SKEP III Home Office Support Site Visit Report

Consultant	Wahib Medanat Consultant Engineer	Rep No.	23-210872021
Contractor	Dijlah Establishment Constr. Contracting	Tender No.	(11/2019/USAID/SKEP/3/S) Schools for a Knowledge Economy Project (SKEP) - Phase (3) Package (1, 2)
Site Name	Jumana Bint Abit Taleb Basic Mixed School - Jerash	Day/ Date	Sat. 21/08/2021
Duration of Project	450 Calendar Days	Total Project Budget	8,314,983.735 JD

(Figure: 05)

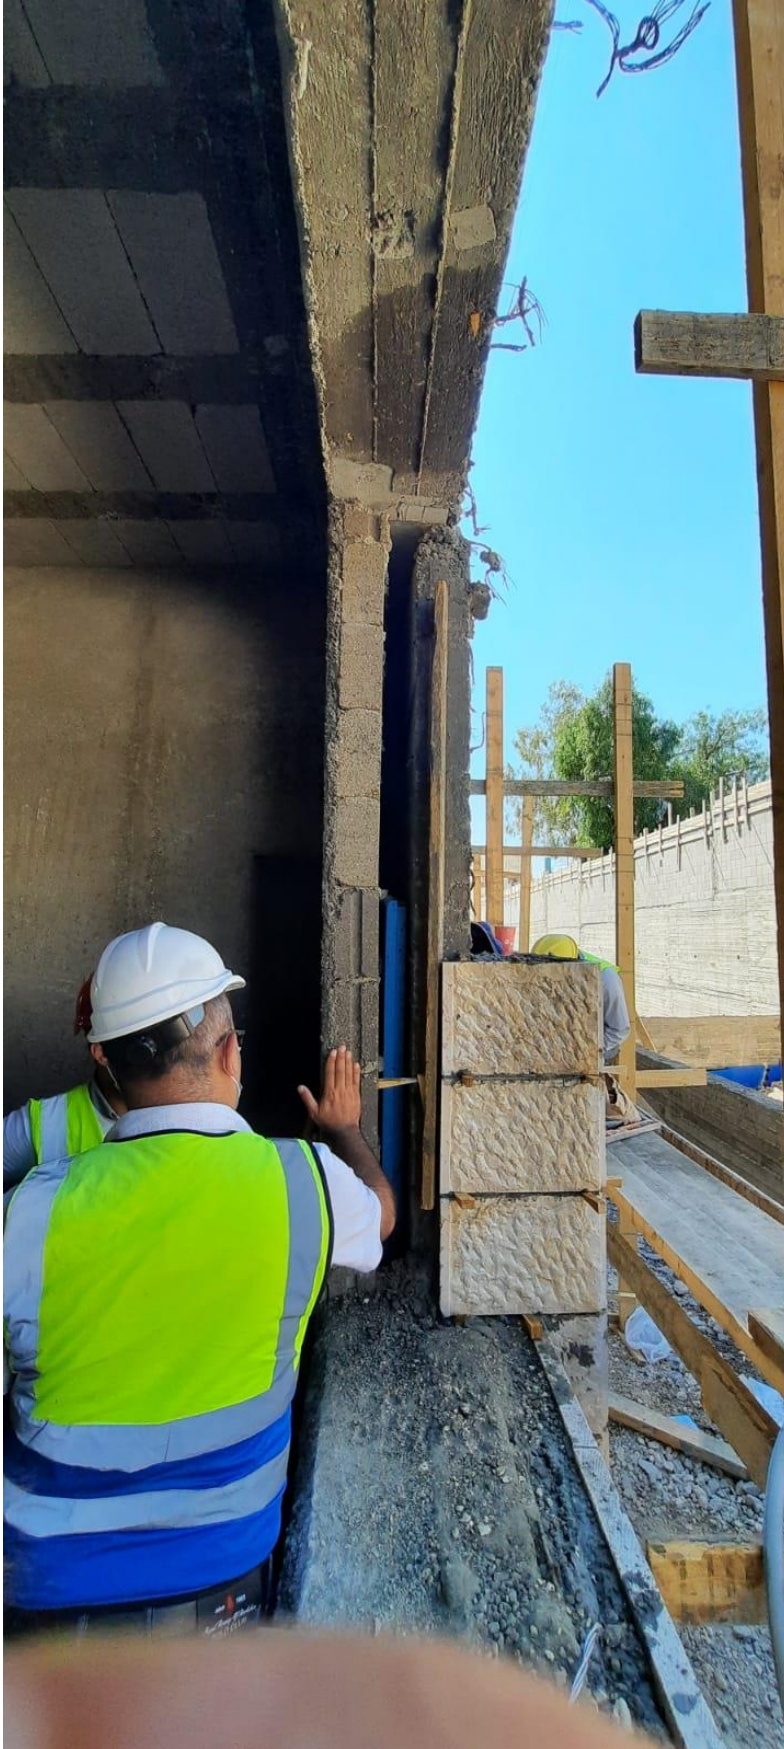
Number of stones were observed at the main entrance to be not complying and the Contractor was requested to replace them in the presence of the stone supplier

(Figure: 09)

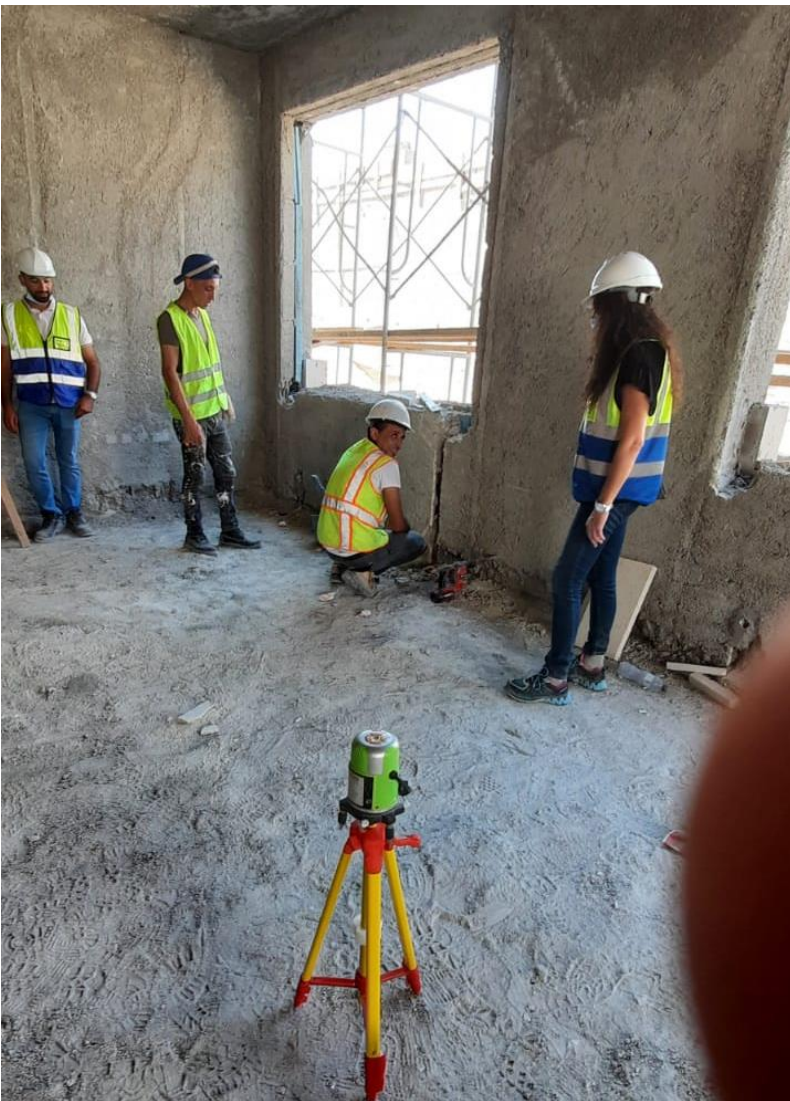
Eng. Natheer advised the Contractor on the right method of installation and stressed on following the architectural workshop drawing
